Enclosure to 12/12/88 and mem  
to HSM from MKK

BWIP SITE TECHNICAL POSITION  
INTERPRETATION OF HYDROGEOLOGIC  
TEST IN DEEP BOREHOLES USING  
DATA OBTAINED BY UPHOLE MEASUREMENTS

**Figure 3-12**

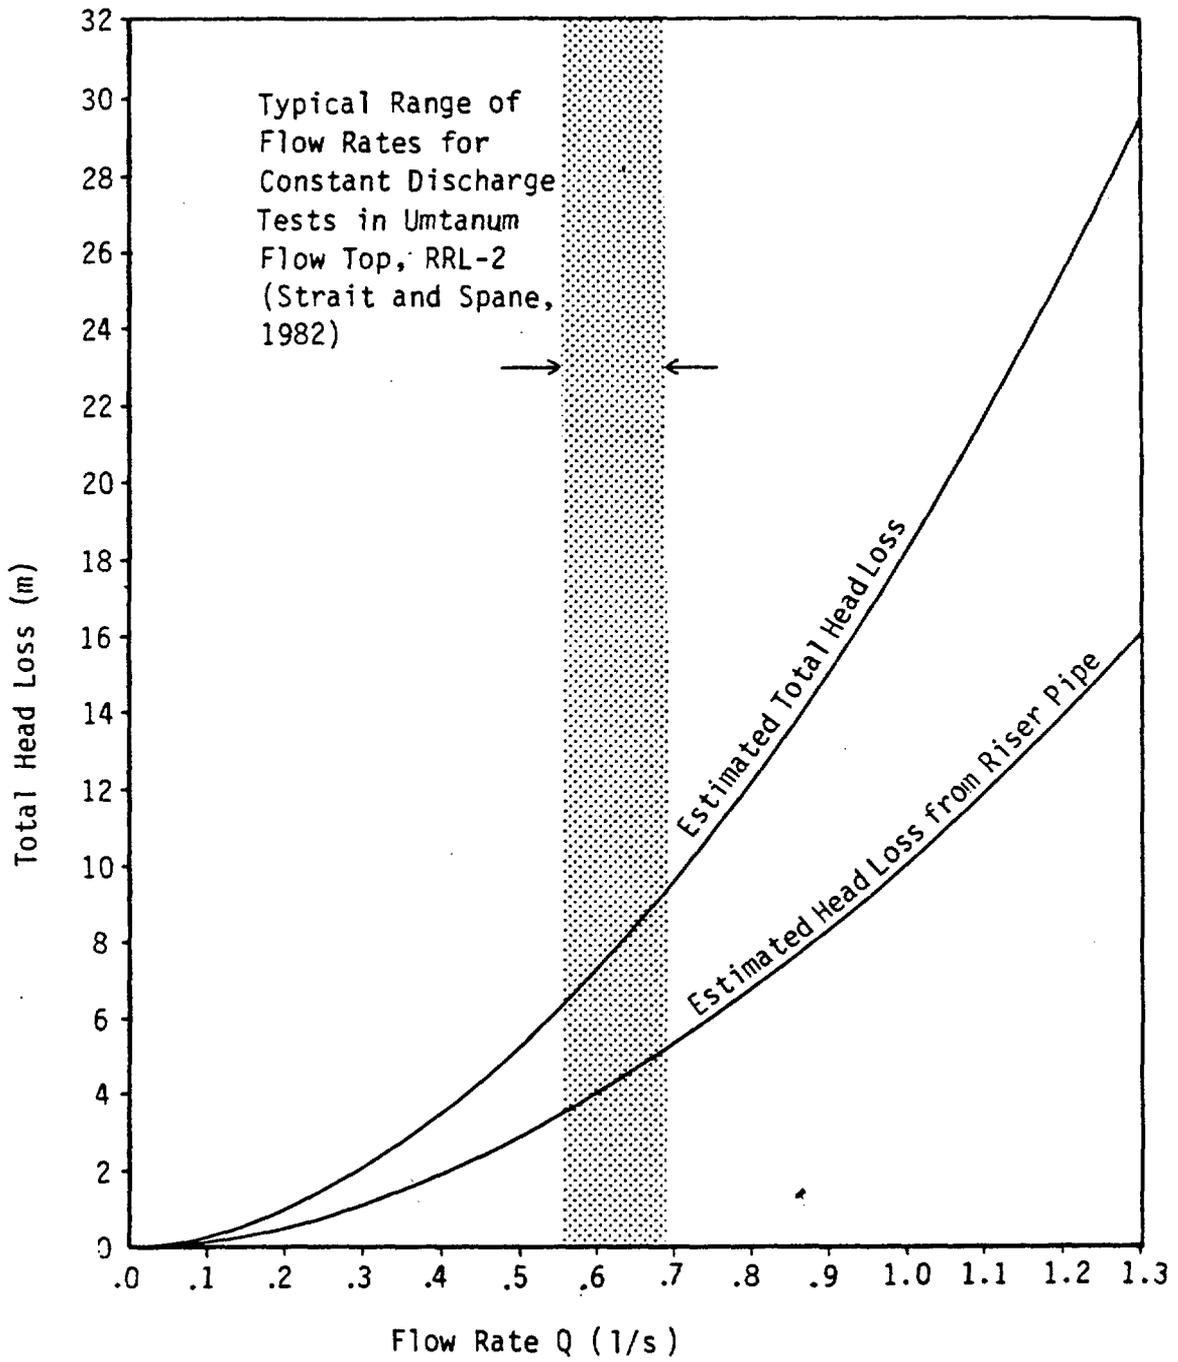
Frictional effects may cause uphole head measurements to be unrepresentative of conditions in the test section. Frictional losses will occur in the riser pipe and through any downhole valving or packers. In this section, frictional losses are estimated to evaluate whether frictional losses, it demonstrates that frictional losses can be significant and should be considered when interpreting uphole measurements of head.

RHO used a variety of equipment and packer arrangements in hydrologic testing at RRL-2. Therefore, based on information from Strait (1984, personal communication) an arrangement of equipment was selected as representative of the possible sources of frictional losses in testing equipment. A schematic of this equipment and the relevant dimensions are shown in Figure 3-12. The four sources of frictional losses considered were:

The total frictional head loss in the wellbore is the sum of the losses from each source considered. Any additional equipment in the borehole would increase frictional losses further. Figure 3-13 shows total estimated frictional head loss as a function of flow rate. Also shown is the head loss due to friction in the riser pipe alone. Note that frictional head losses in the riser pipe, which are the most easily estimated, account for greater than 50 percent of the total estimated losses. For a flow rate of about  $6 \times 10^{-4} \text{ m}^3\text{s}^{-1}$ , approximately the flow rate used in RHO pump tests in the Composite Umtanum Flow Top at RRL-2 (Strait and Spane, 1982), total frictional losses are about 7 m. This minimum estimated frictional head loss is significant. Although frictional losses can be estimated it is normal practice to calibrate equipment for frictional losses so that losses can be considered in the analysis of test data. To our knowledge this has not been done at the BWIP site.
